01 31 13.13 BACNET AND OTHER DEVICE INTERFACES INTEGRATION

Robert H. Babcox Justice Complex
20 South County Street
Waukegan, IL 60085
Medical Unit AHU Replacement

Lake County Smoke Evac and AHU BACnet Single Line Diagram

NETWORK RISER

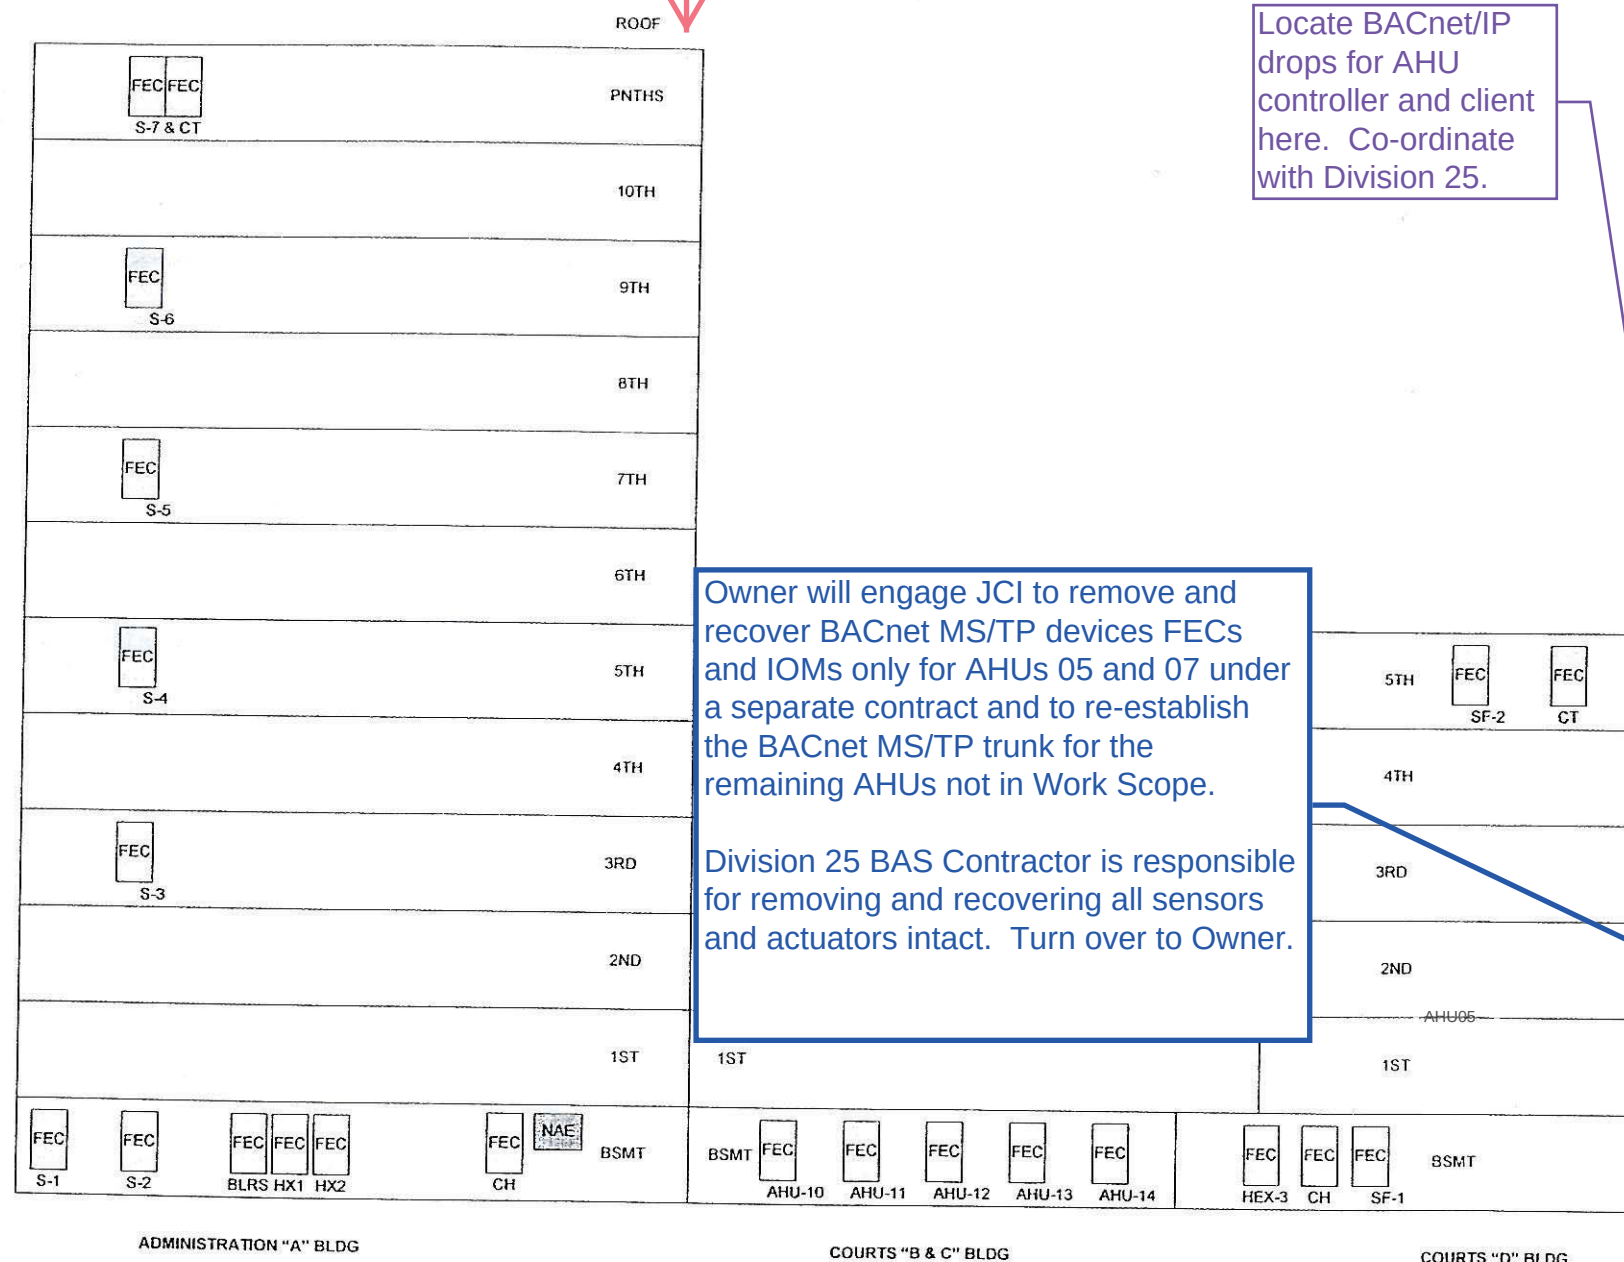
Locate BACnet/IP drops for AHU controller and client here. Co-ordinate with Division 25.

See photos below showing Central Control BAS panel location and networking arrangements.

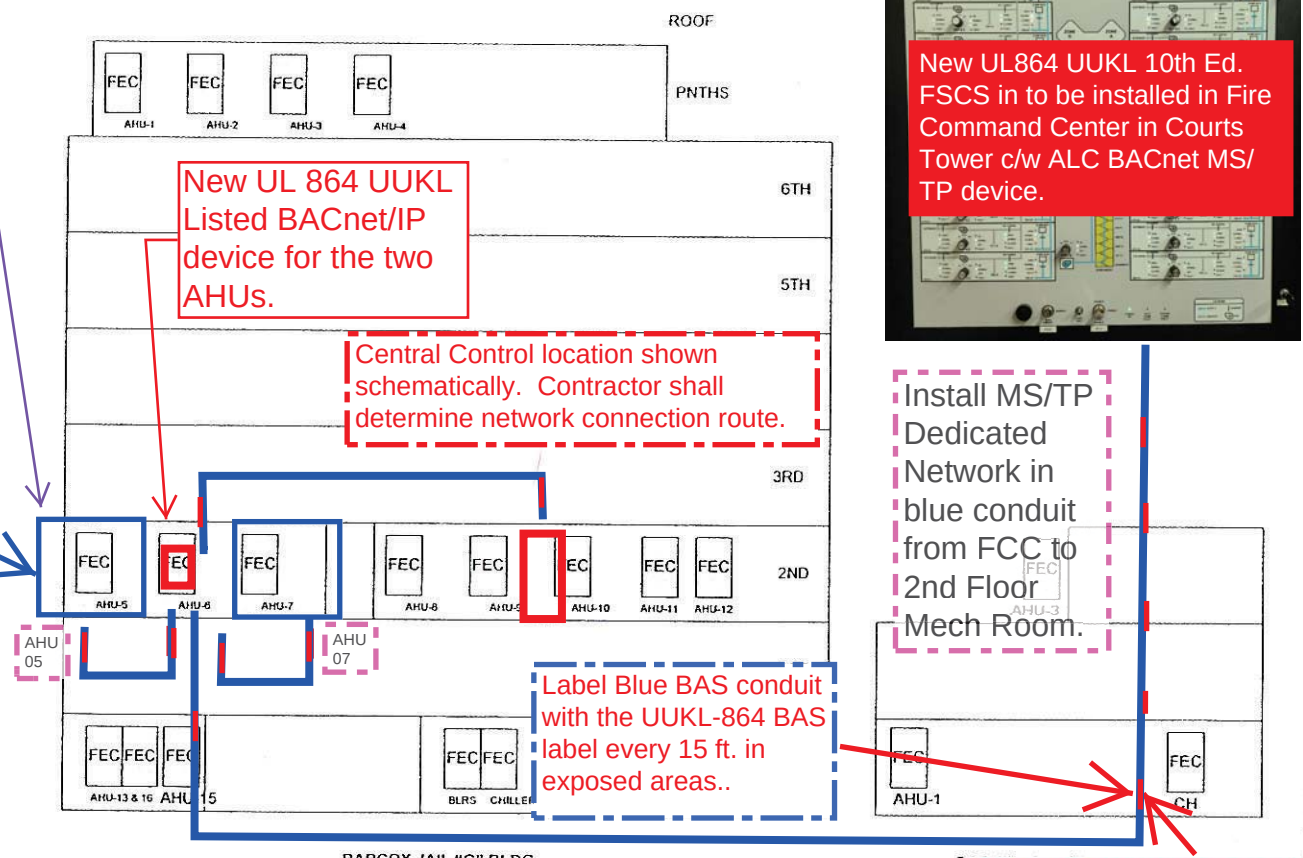
Owner will engage JCI to remove and recover BACnet MS/TP devices FECs and IOMs only for AHUs 05 and 07 under a separate contract and to re-establish the BACnet MS/TP trunk for the remaining AHUs not in Work Scope.

Division 25 BAS Contractor is responsible for removing and recovering all sensors and actuators intact. Turn over to Owner.
